From: "Elhassan, Walid"
Sent: 12/05/2021 12:27 PM
To: "Michael Prendergast" <Michael.Prendergast@jwland.com.au>;
"elizabeth@planned.net.au" <elizabeth@planned.net.au>
Subject: TP Further Information Request and RE: Entities Comment - DA-202037894 Block 12 Section 51 Lyneham
Importance: High

Northbourne Avenue Precinct Map and Code

PROJECT NAME:
LYNEHAM STAGE 3
BLOCK 12 SECTION 51, LYNEHAM

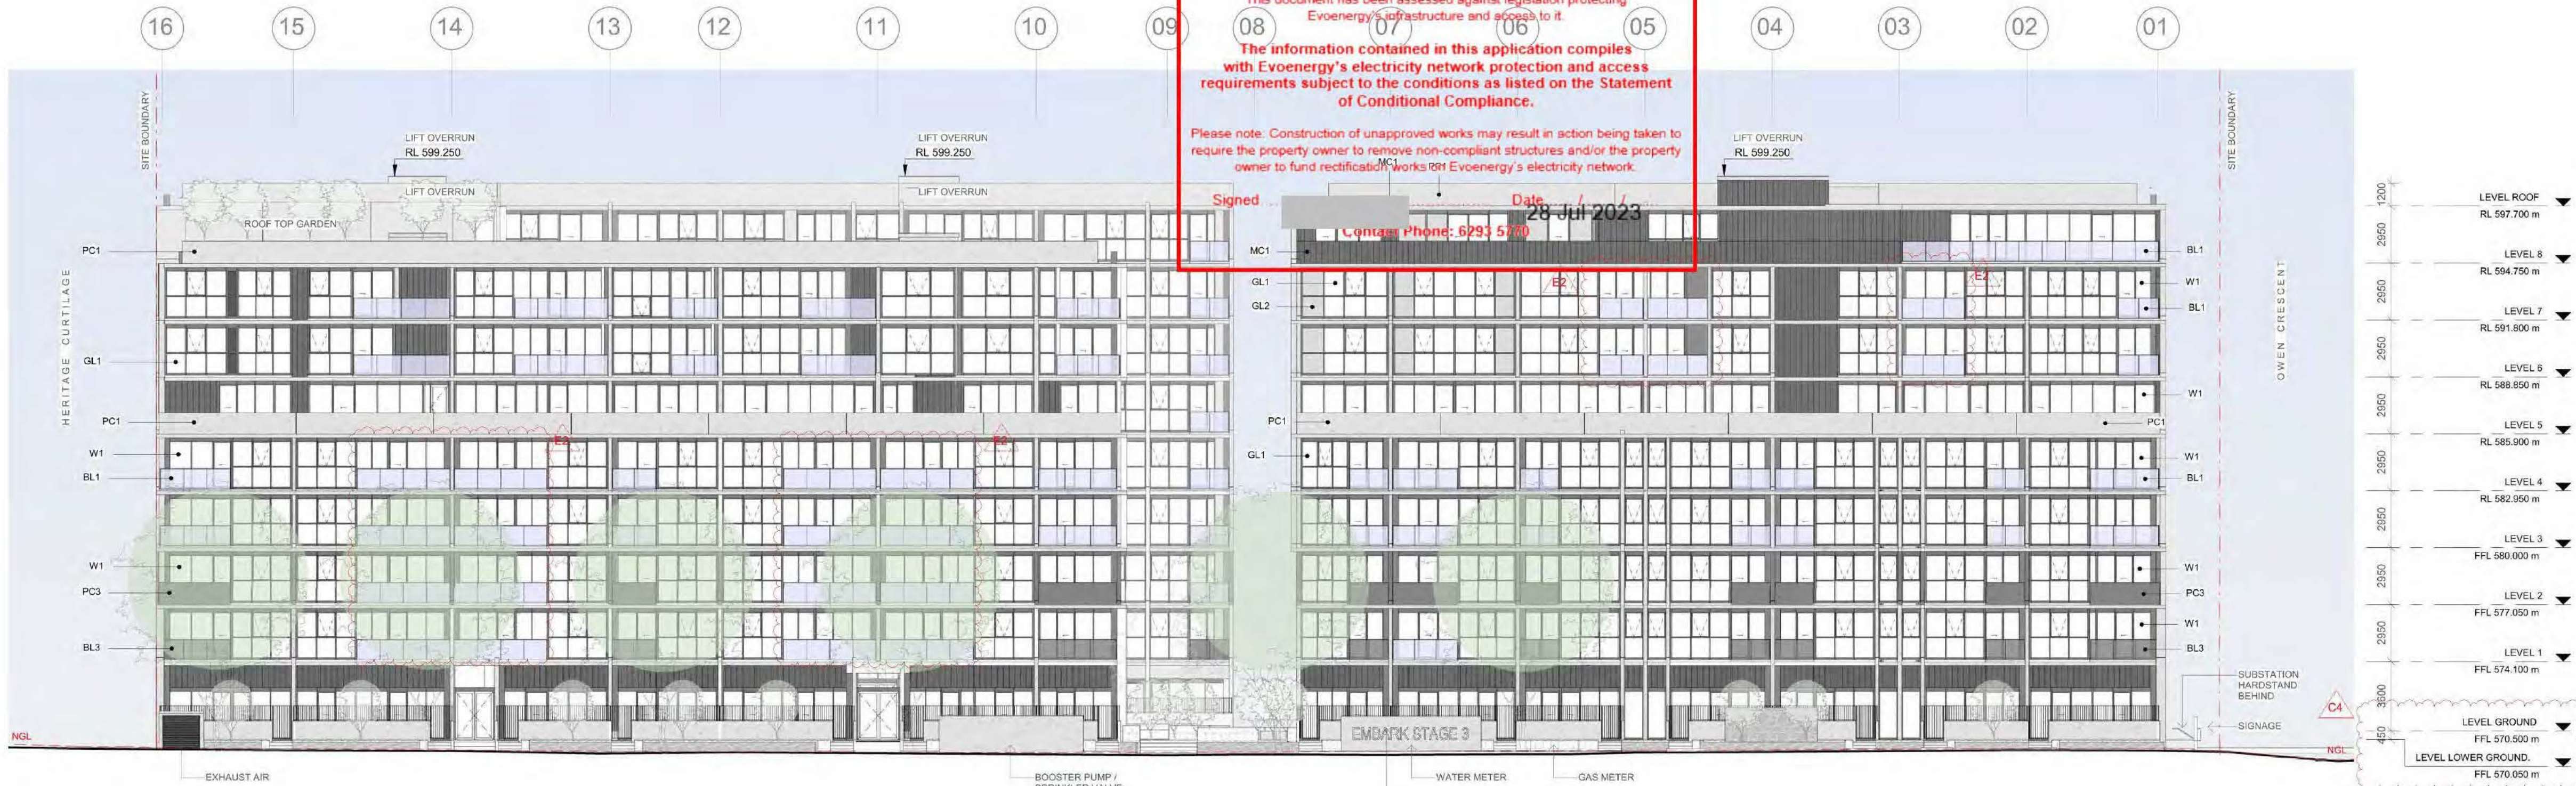
While the Authority supports the modest improvement in dwelling mix, we cannot assess the functionality of the living space/lay-out without updated plan floor plans showing internal layouts.

To complete this review the Authority requests further information regarding the updated lay-out due to change from 1 bedroom to 2-bedroom apartments. Floor plans with internal layouts (walls, fittings, fixtures etc) are required to determine whether functional layouts are achieved in this amended design.
